Date: March 11, 2024

Addendum No. 3**Request for Proposal Call No. NRFP2024-027
CONSTRUCTION OF CENTURY GARDENS YOUTH HUB**

**ELECTRICAL ADDENDUM EA-3
CENTURY GARDENS COMMUNITY YOUTH HUB
342 VODDEN STREET EAST
BRAMPTON, ON
PROJECT NO.: 2205
MARCH 7, 2023**

DRAWING TITLE
AUDIO VISUAL SYSTEM LAYOUT-OVERALL

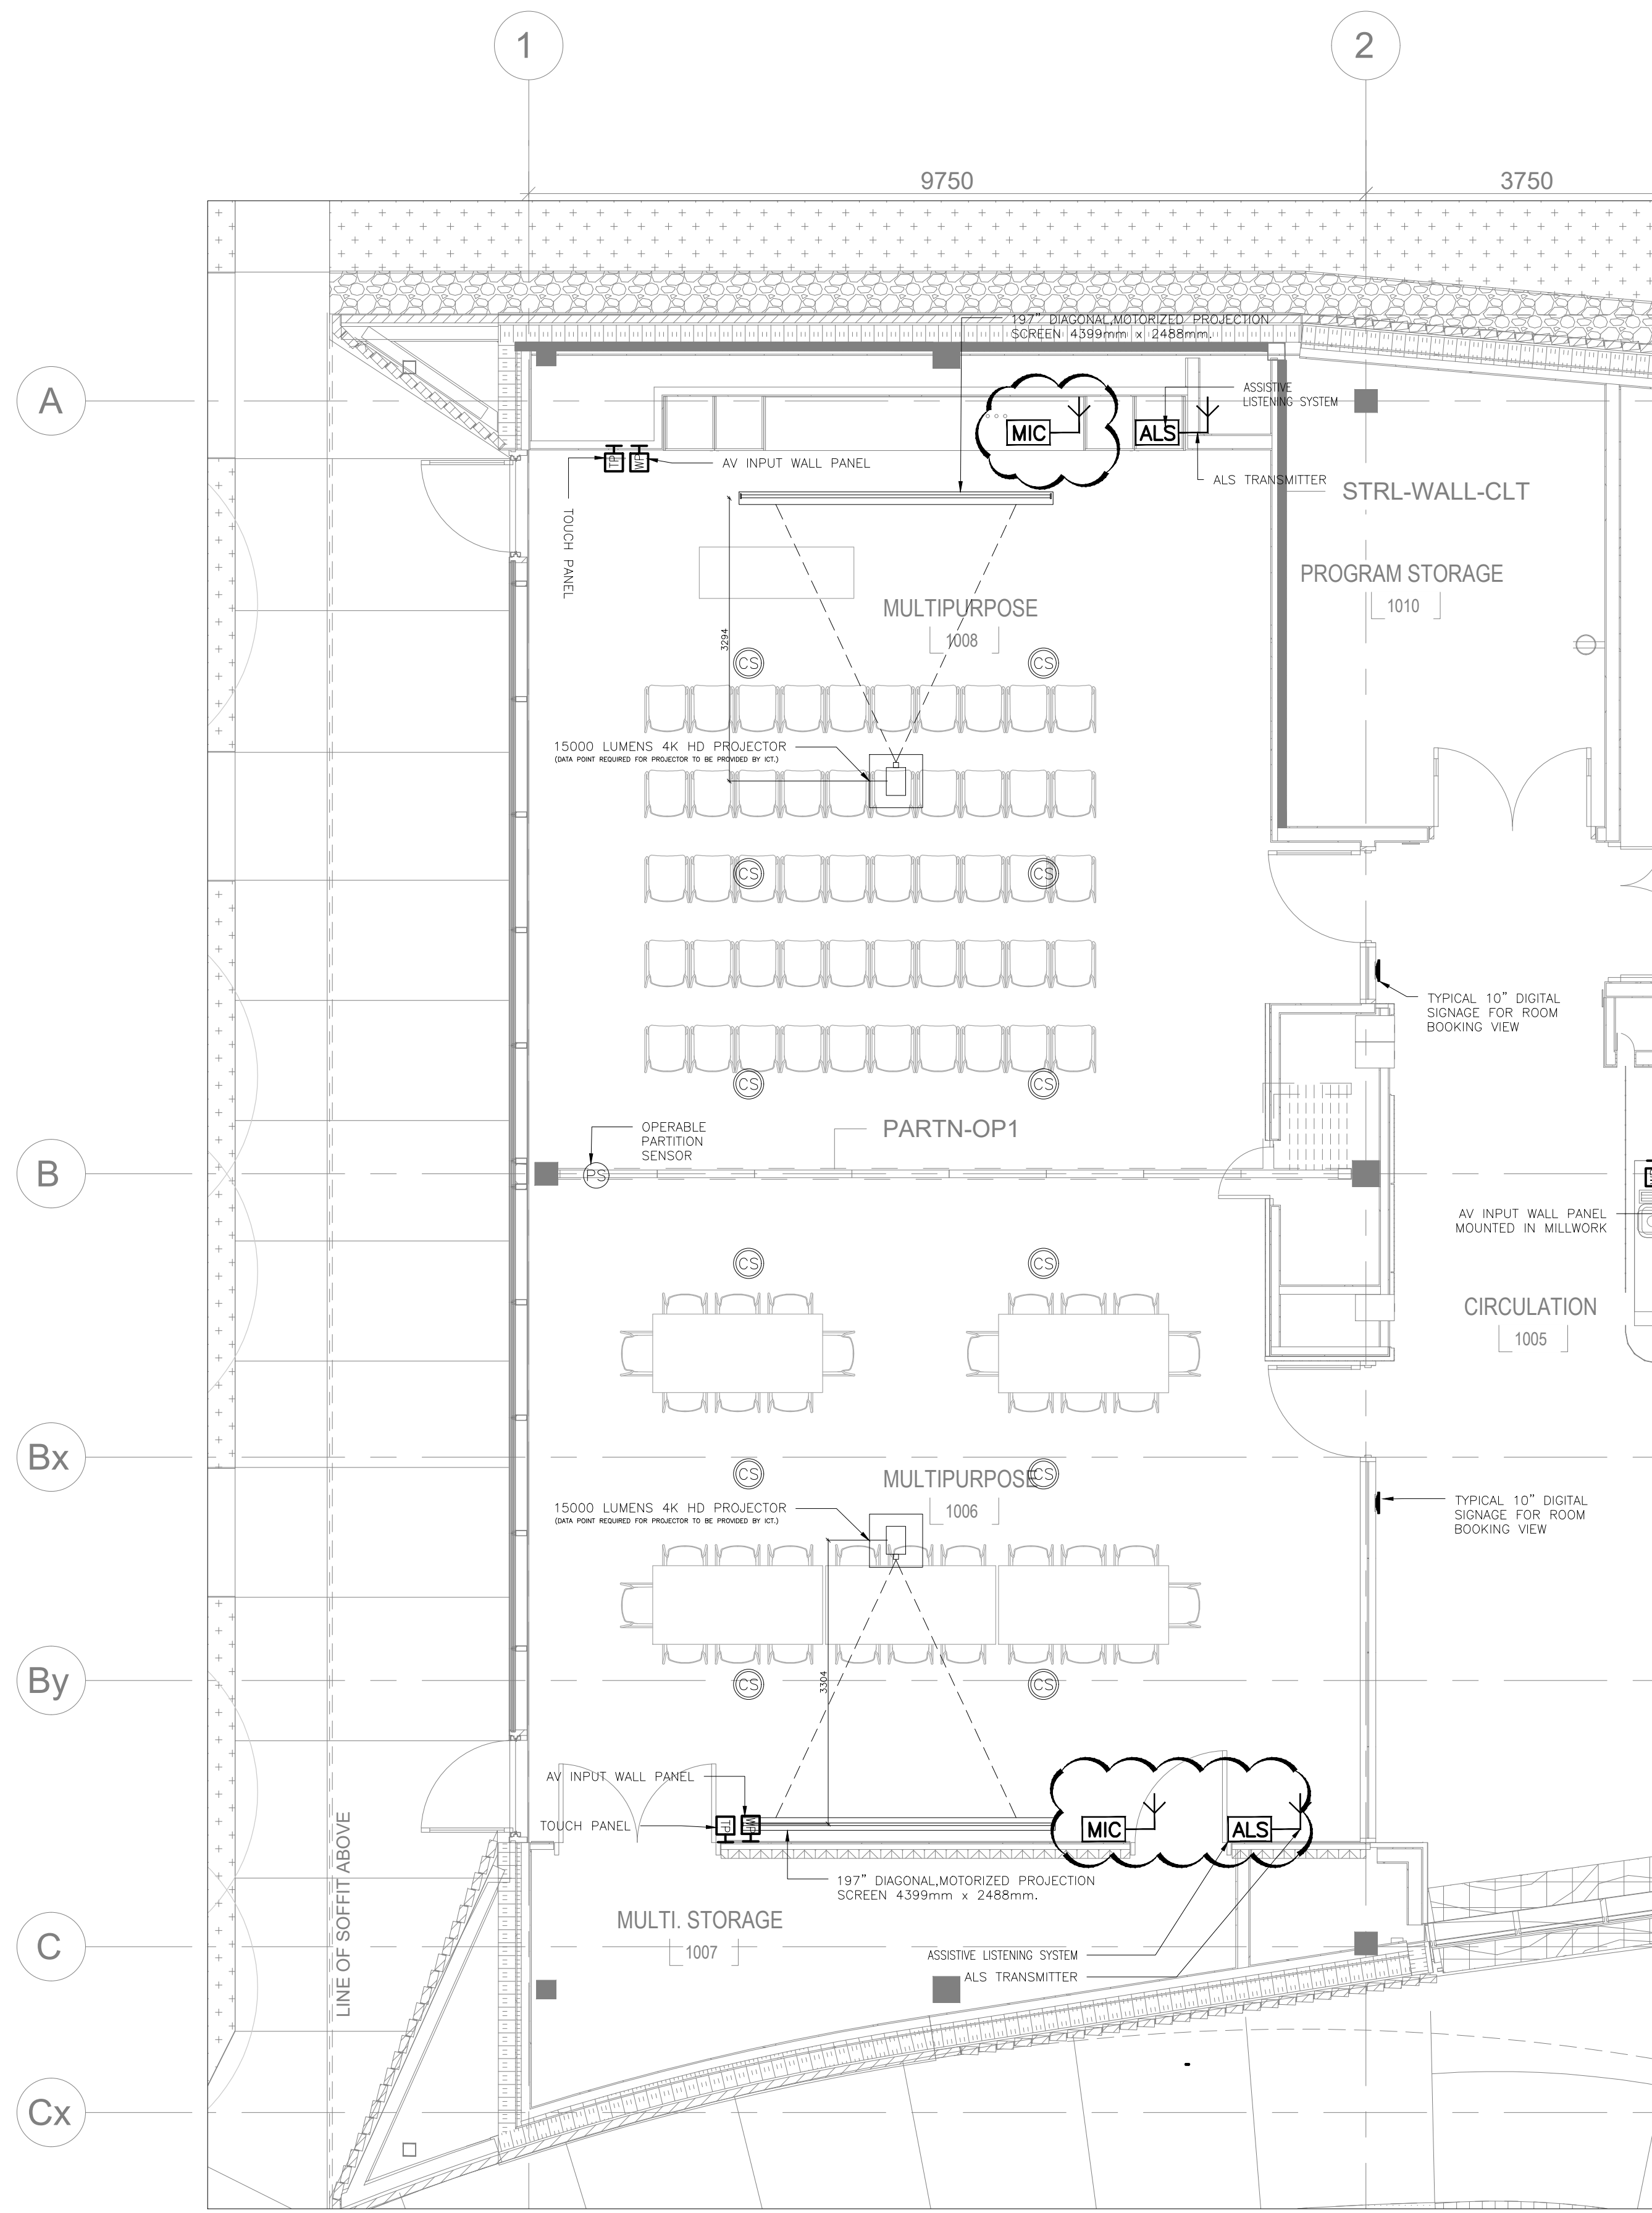
1. Revise AV System Drawings as per attached Drawings E500 to E505 and E508.

SCALE N.T.S.
DATE **FEB.29'2024**
PROJECT NUMBER **22-144**
DRAWING NUMBER **E508**

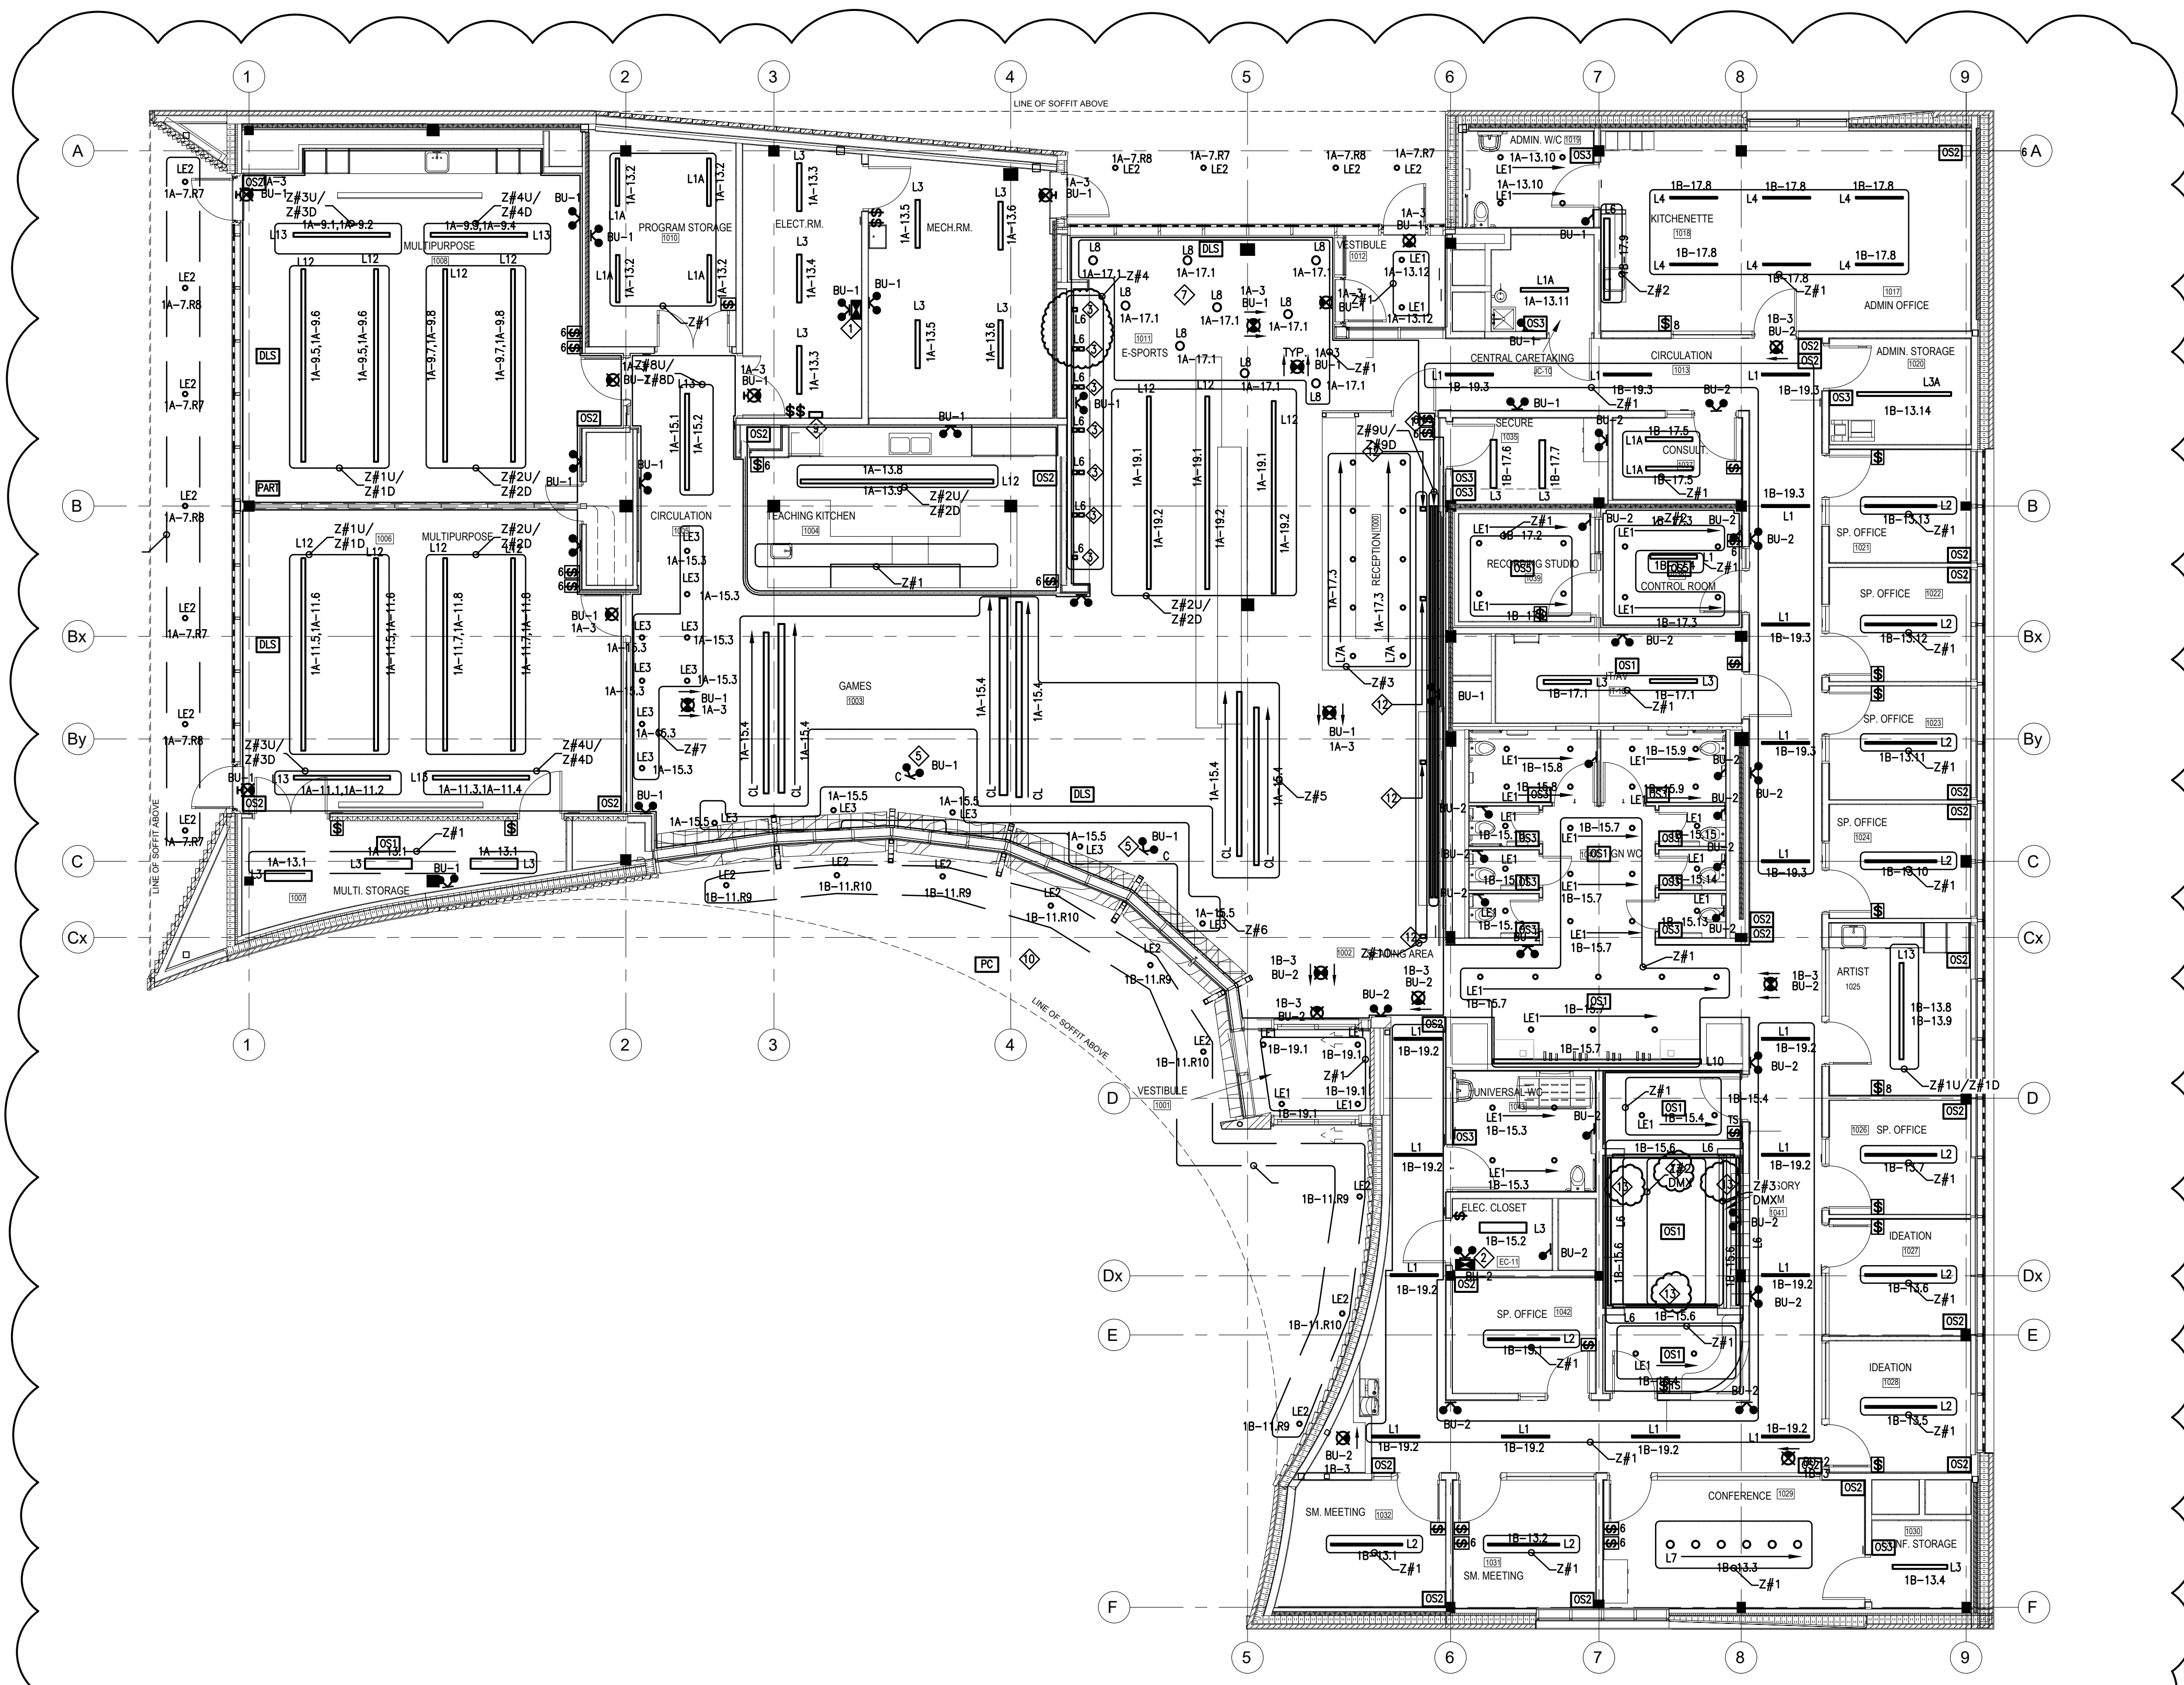
- 1) Please confirm whether all Connection Panels include AV in/output panels as Floor Box
- 2) The network diagram (E508) shows different quantities of the following compared to the floor plan (E500). Unaccounted items are listed below :
 - 2 x AV input plate @ multipurpose rooms (1.0 ea)
 - 2 x presentation TX @ small meeting rooms (1.0 ea)
 - 2 x presentation TX @ ideation rooms (1.0 ea)
 - 2 x mic antenna @ multipurpose rooms (1.0 ea)
